PR/1408/21

Reg. Reference: SD21B/0469 **Application Date:** 06-Sep-2021

Proposed Development: New front porch and canopy, single storey rear and side extension, dormer window to rear roof, widening vehicular access, 'Velux' window to the front, some internal alterations and associated site works.

Location: 2, Aranleigh Gardens, Rathfarnham, Dublin 14

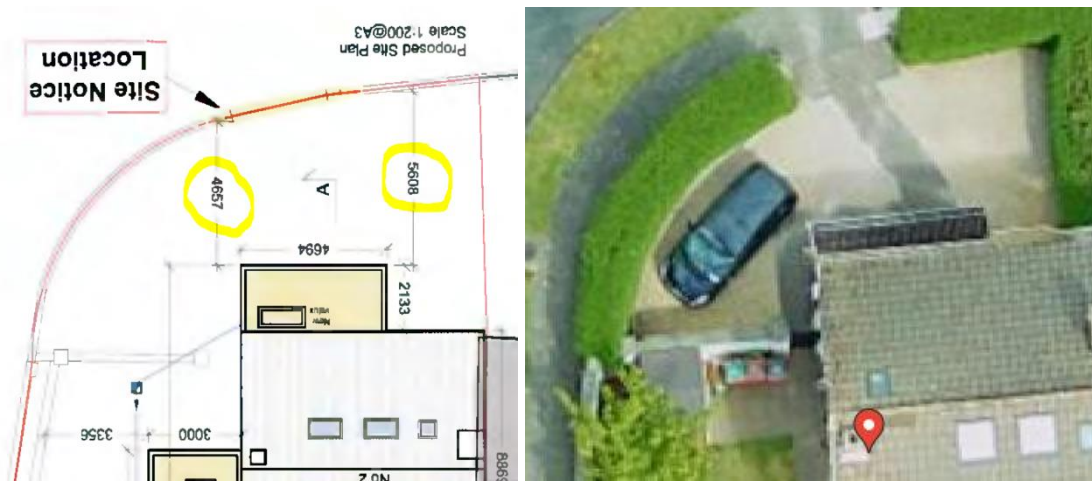
Access & Roads Layout:

The drawing submitted does not clearly show the layout/dimensions for the existing or proposed vehicular entrance and these must be provided, and extents clearly shown.

Noted that there already exists a poor visibility splay on both sides for vehicles egressing due to the existence of a tall dense hedge.

Roads Dept seek min 6m from front of building line to front boundary wall. The dimensions proposed fall well short of this distance and raise concerns regarding vehicular access and egress from the proposed development, and will require an AutoTRAK Swept Path analysis drawing to illustrate these movements can be carried out safely.

Roads recommends that additional information be requested from the applicant:

1. *The applicant shall submit a revised layout clearly showing:*
 - a. *Where the existing piers are located, and the dimension between.*
 - b. *The pier proposed to be removed, the new pier proposed location and the dimension between.*
 - c. *3no. distance measurements from corner of new porch to the boundary as it sweeps around.*
2. *AutoTRAK Swept Path analysis drawing showing the traffic movements required for a vehicle to safely access and egress the site.*
